February 24, 1994
Fort St. Vrain
ISFSI
P-94018

Docket No. 71-9253

SUBJECT: Response to the NRC's Request For Additional
Information Regarding the Model No. TN-FSV Packaging

**PSC RESPONSES TO NRC QUESTIONS ON THE
TN-FSV IRRADIATED FUEL SHIPPING PACKAGING**

FIGURE 2.10.3-1
SIDE CRUSH TEST CONFIGURATION

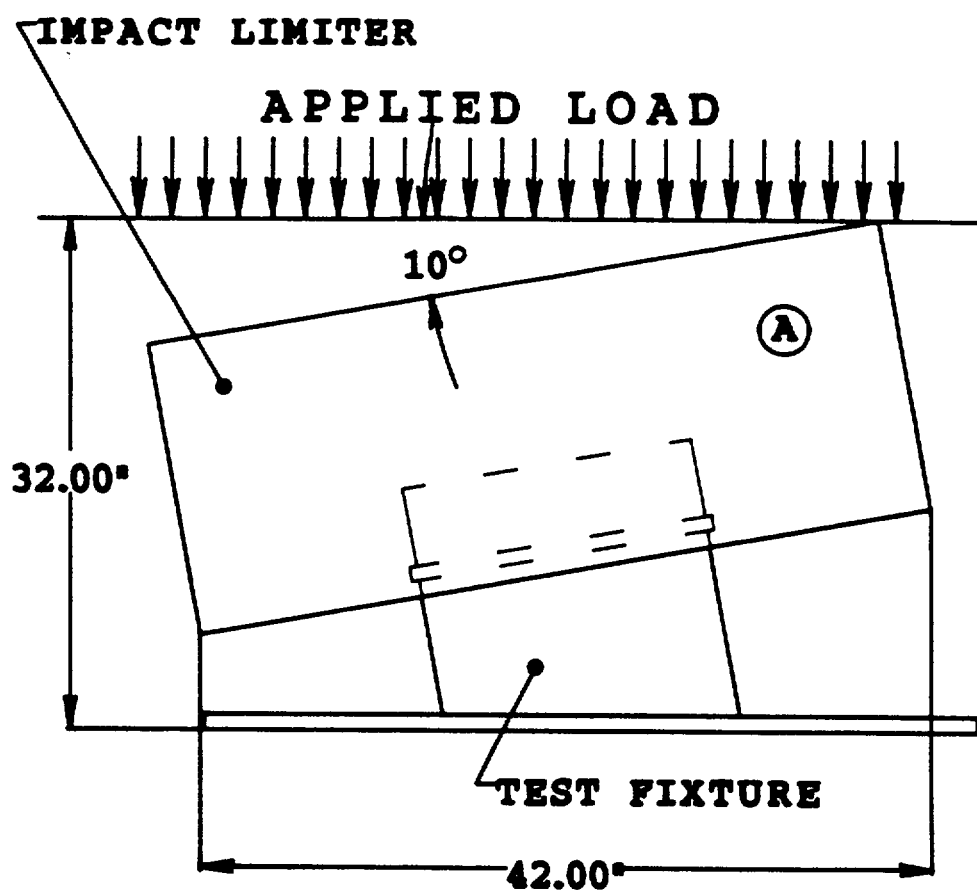
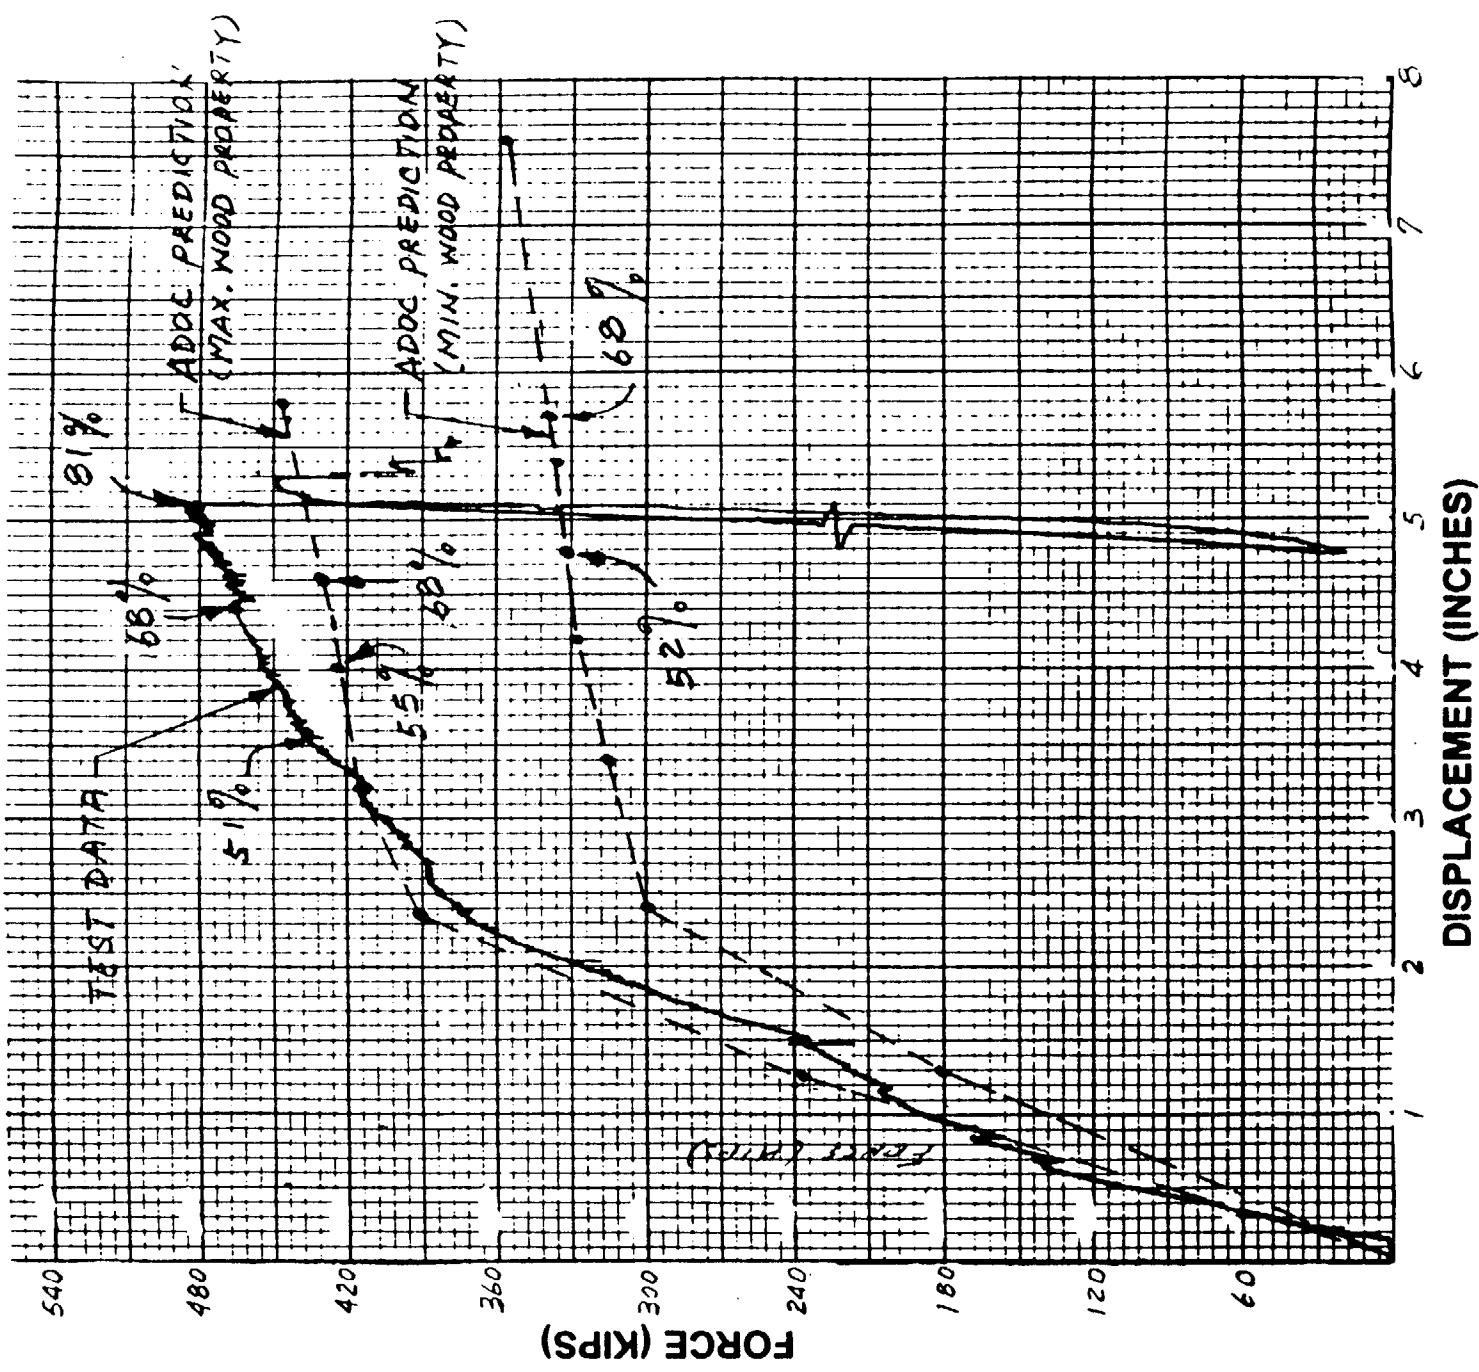
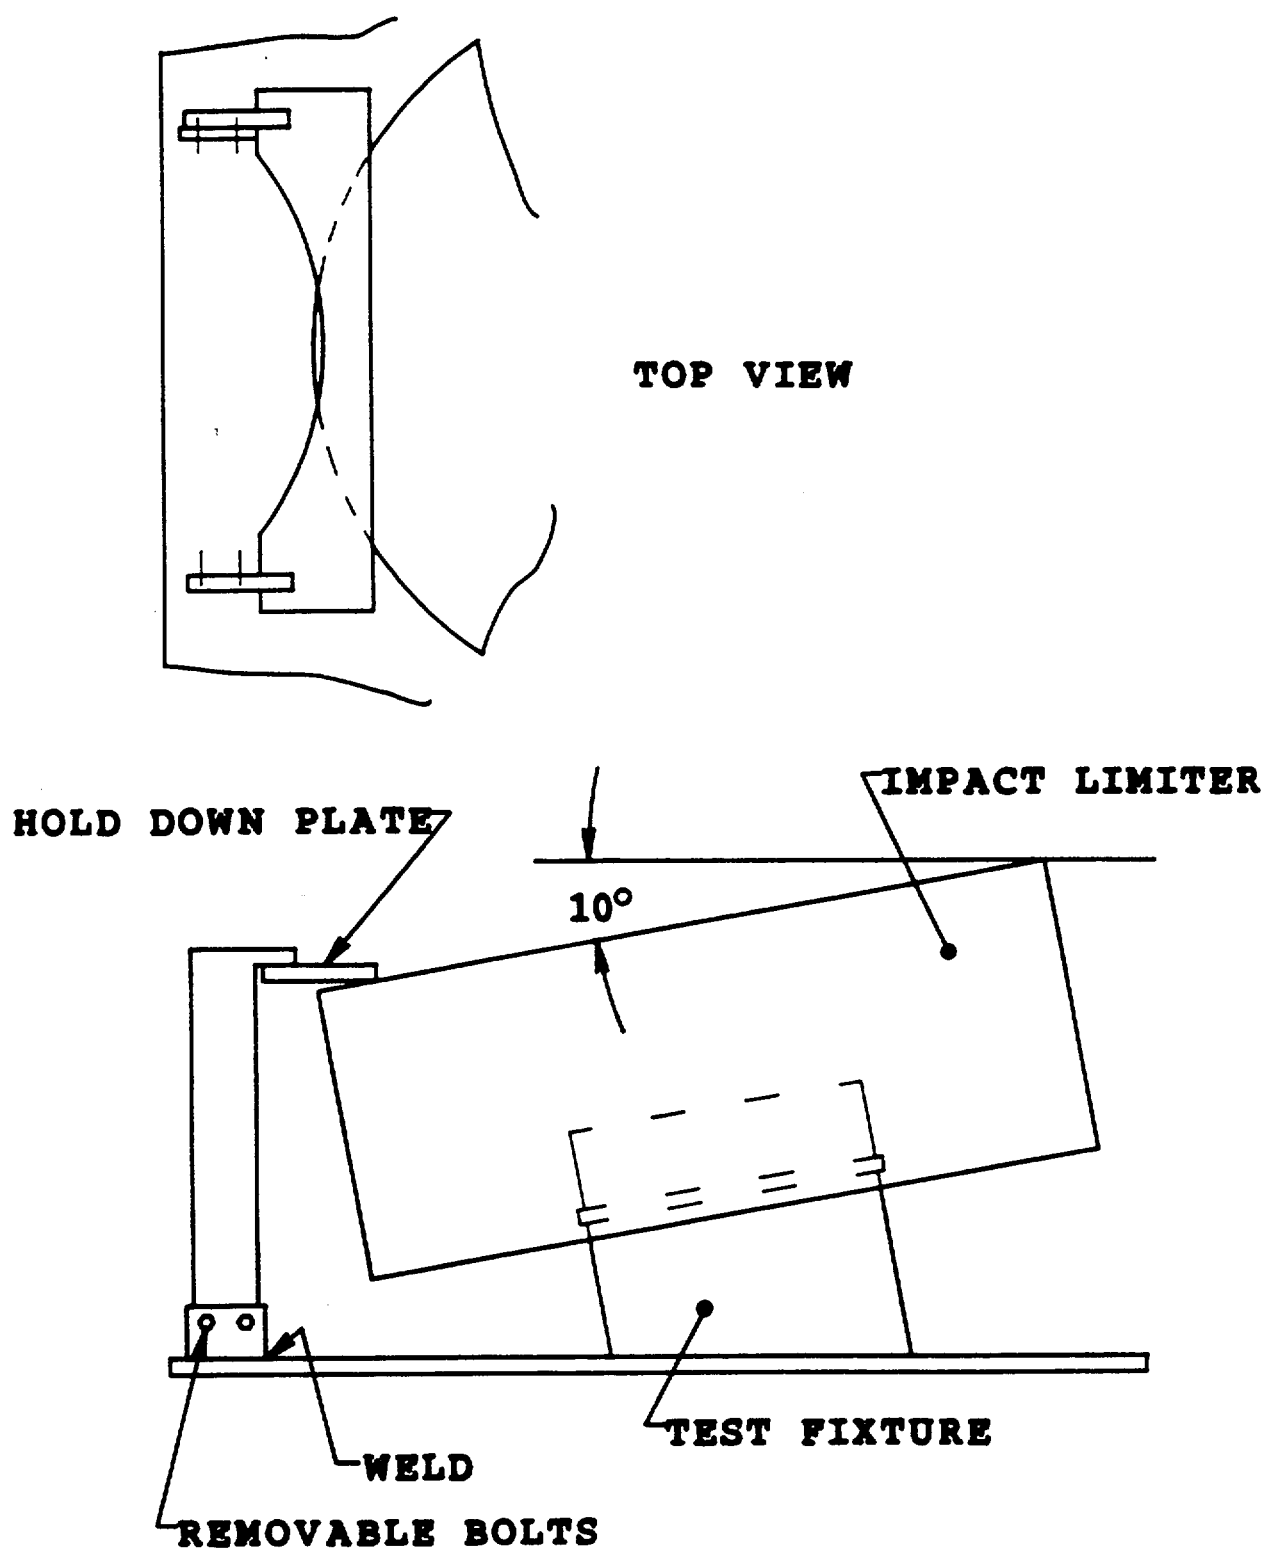
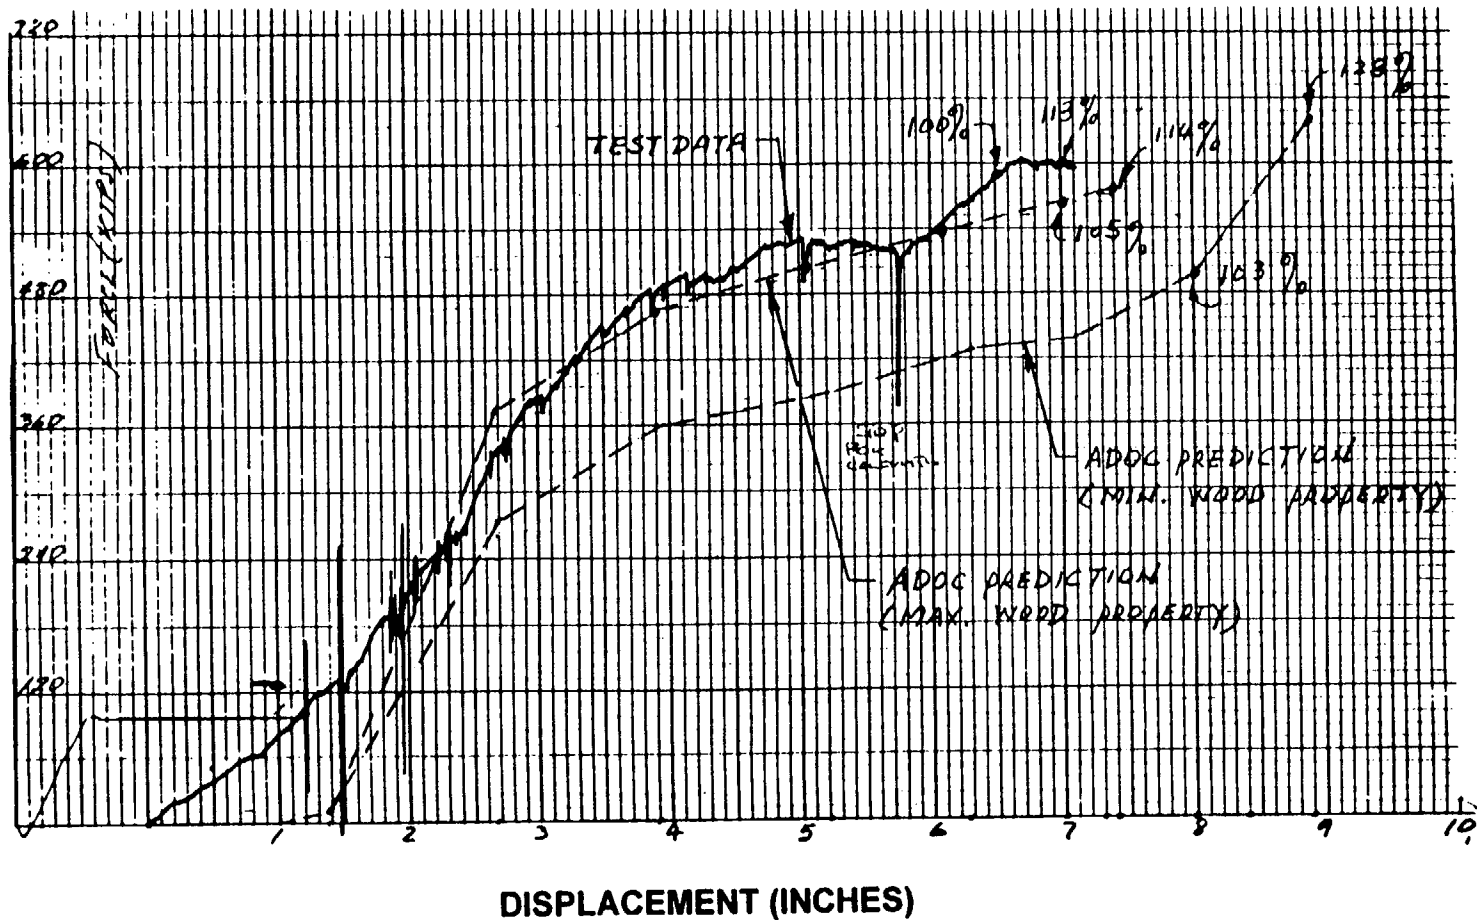
Revise the application to show that the impact limiters remain attached after the 30-foot drop and puncture tests.

During the side crush test, five of the six attachment bolts broke. The bolts broke after 81% of the energy needed for the side drop was absorbed. This was well above the energy to be absorbed by a single impact limiter in either a side drop (50%) or a shallow angle drop (68%), thus providing evidence that the impact limiters would remain attached after a 30-foot drop.

FIGURE 6-2
MODEL FSV-1 CONFIGURATION - TWO DIMENSIONAL MODEL

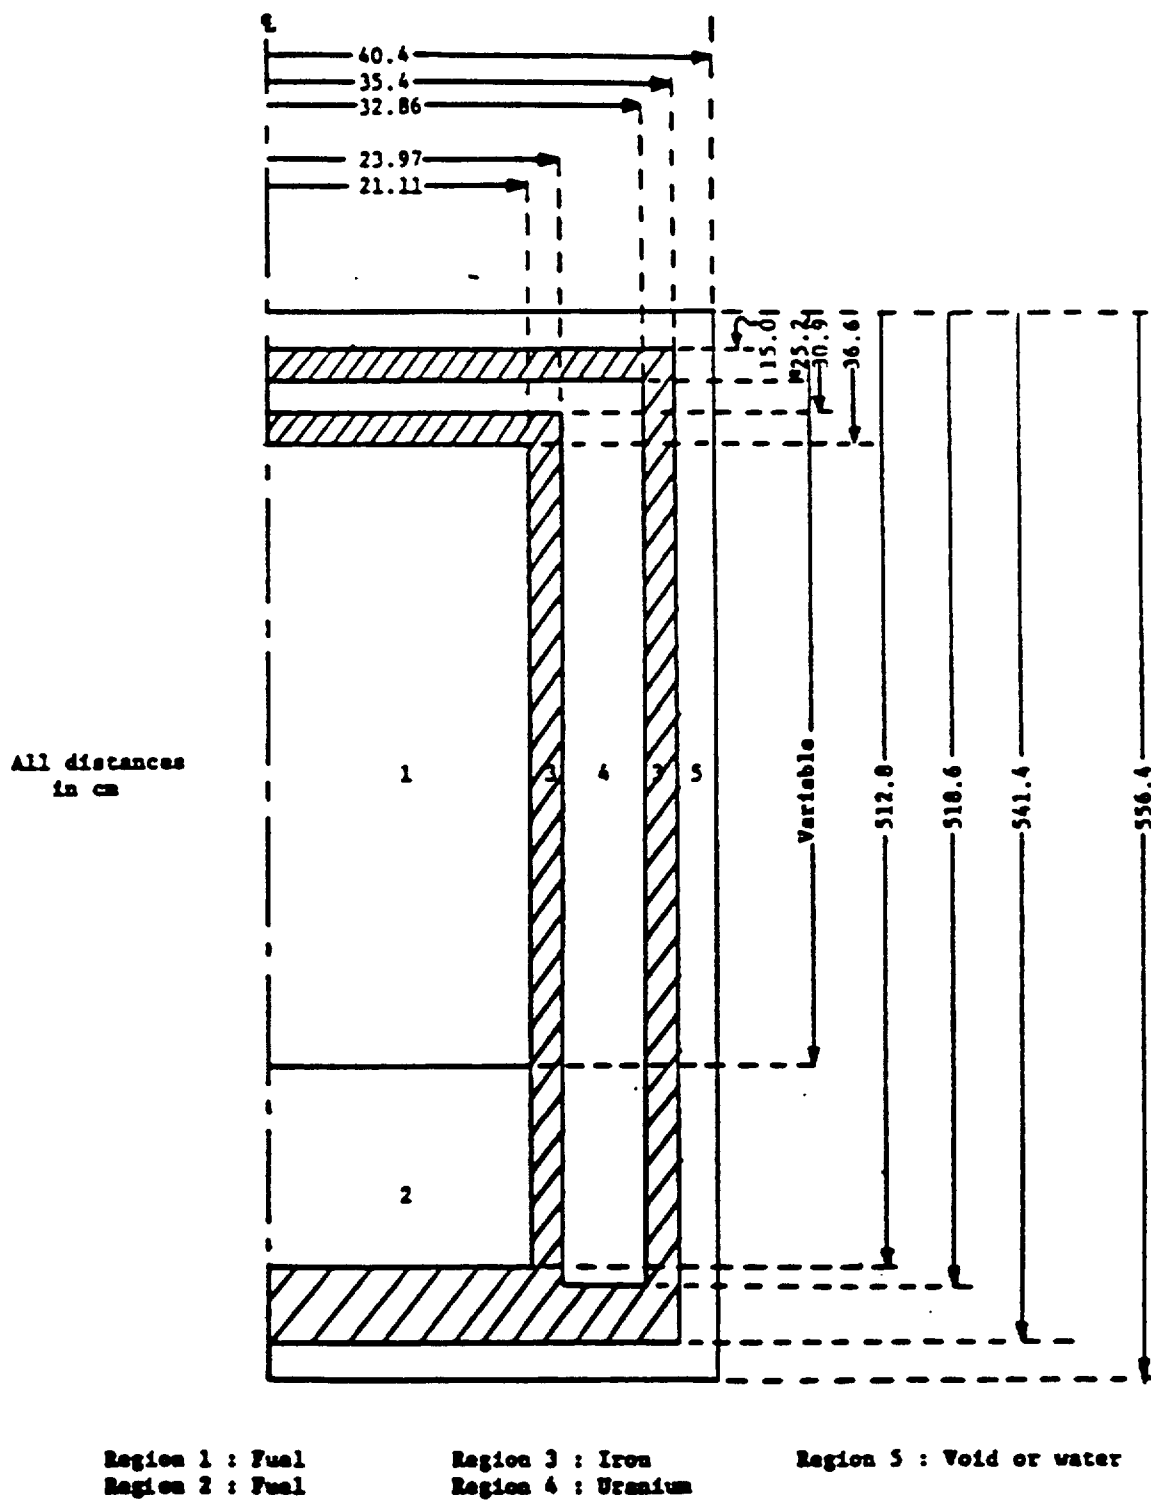
Provide the data that were used in the criticality computer programs in sufficient detail that the calculations can be repeated with an alternative computer code.

The material concentrations used for most reactive unflooded (Table 14) and flooded (Table 15) conditions are listed on the following tables. The region number corresponds to SAR Figure 6-2 and SAR text in section 6.4.2.a and 6.4.2.b.
